CITY OF ALBUQUERQUE

Re: Maher Warehouse, 4120 Culter Ave. NE, Grading and Drainage Plan
Engineer's Stamp dated 05-16-08 (H-17/D086A)

Re: Maher Warehouse, 4120 Culter Ave. NE, Grading and Drainage Plan
Engineer's Stamp dated 04-16-08 (H-17/D086A)

Based upon the information provided in your submittal received 10-30-15, the above referenced plan cannot be approved for Building Permit until the following comments are addressed:

SHEET
TCL
1 OF 1

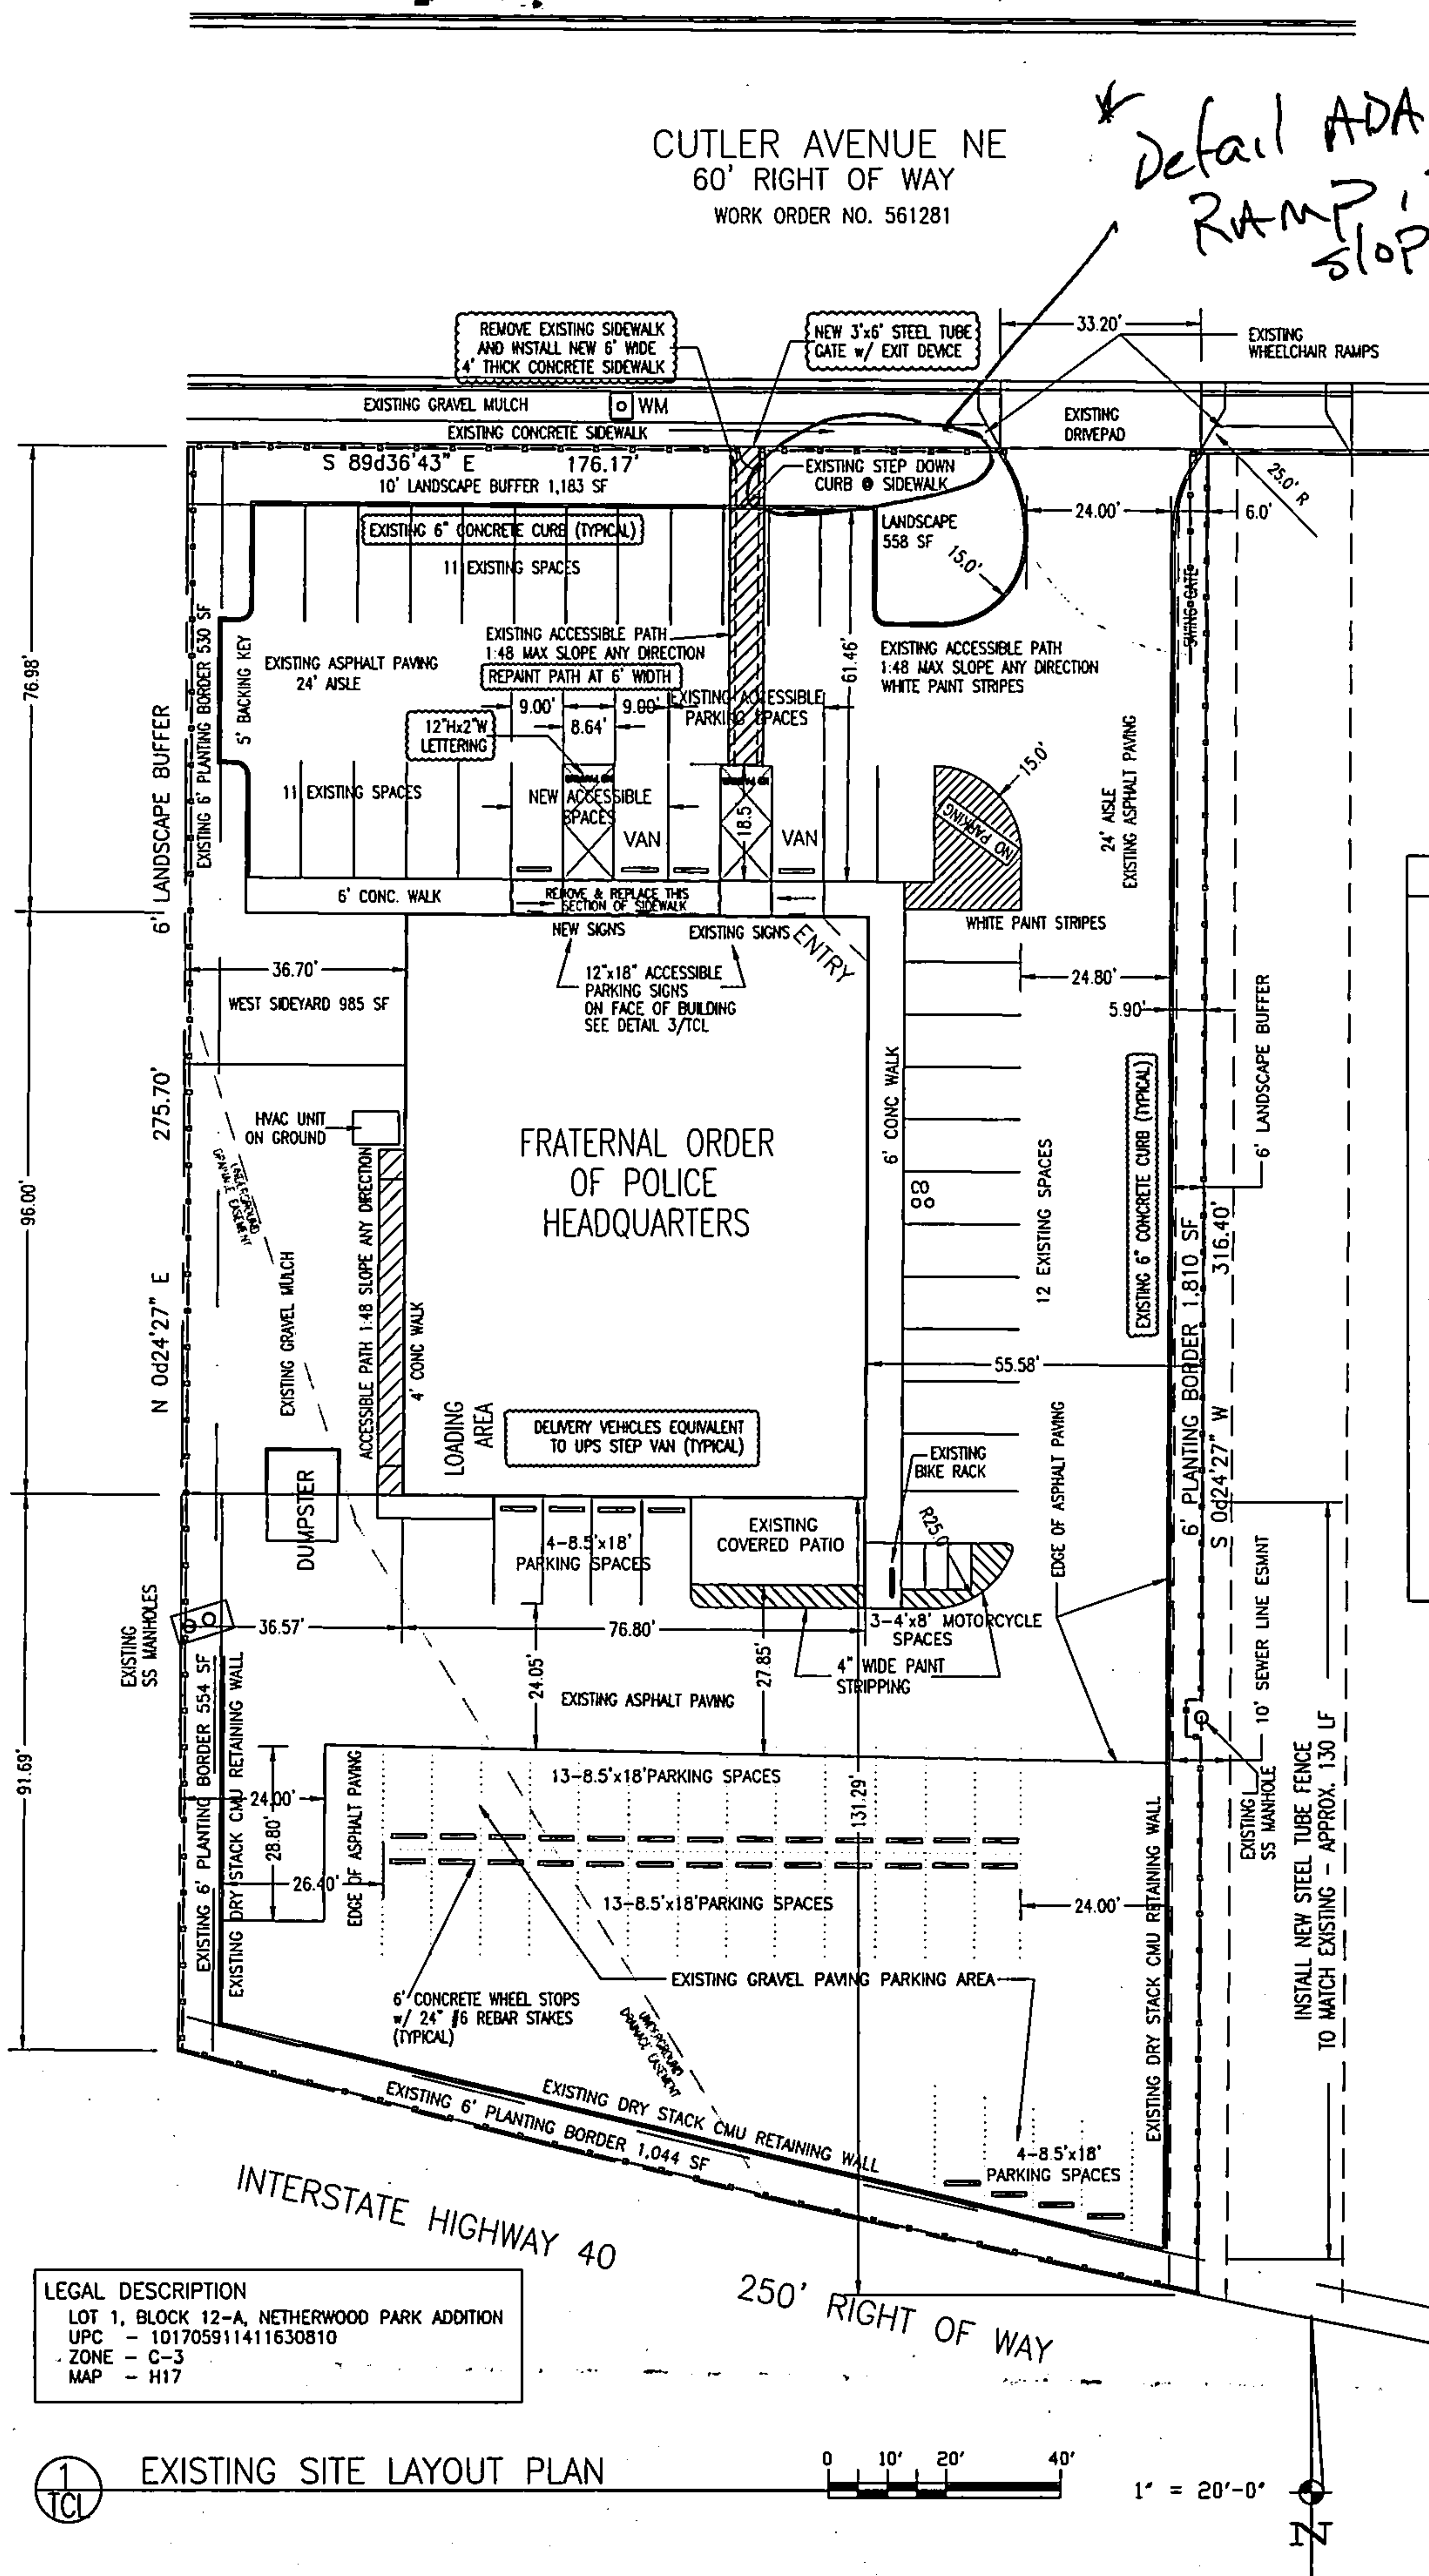
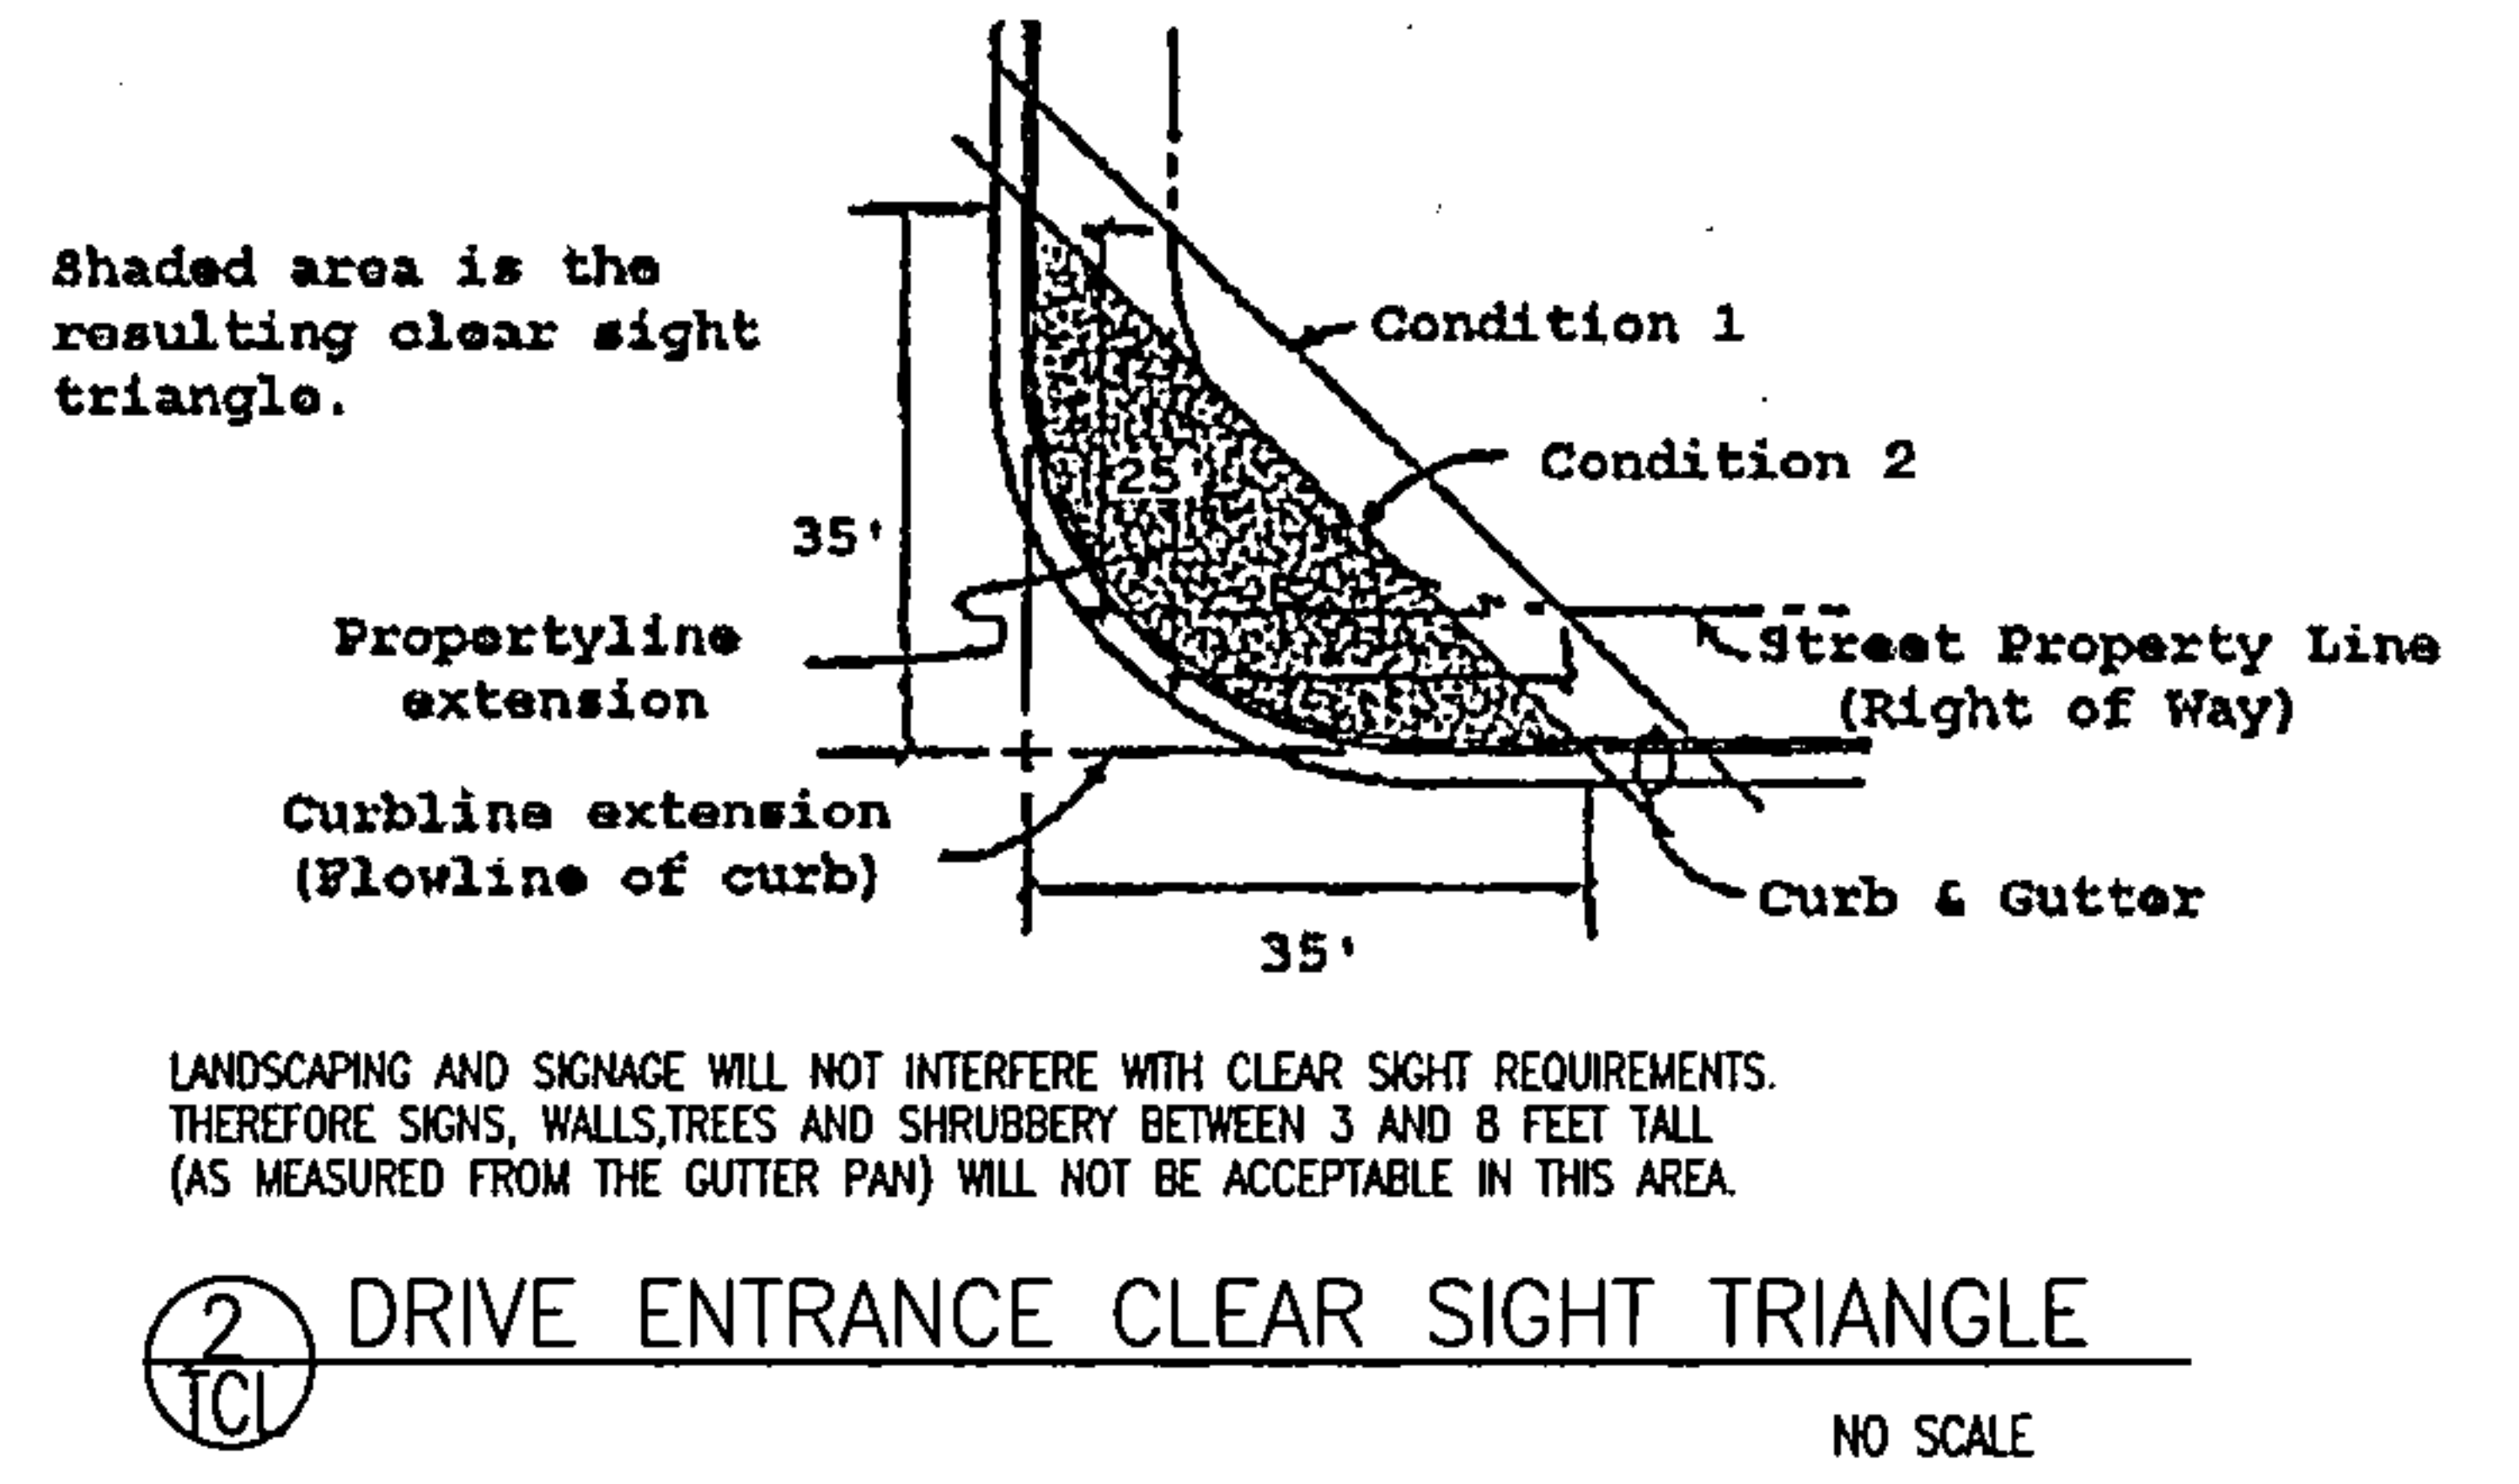
Attached is a marked up drawing of your submittal, notating the ADA sidewalk in question. Per DPM an ADA accessible pathway is required from the public ROW. You are notating that there is a step. Also, the resubmittal will need a new Stamp Date.

** Detail ADA Reg RAMP, specifying slope*
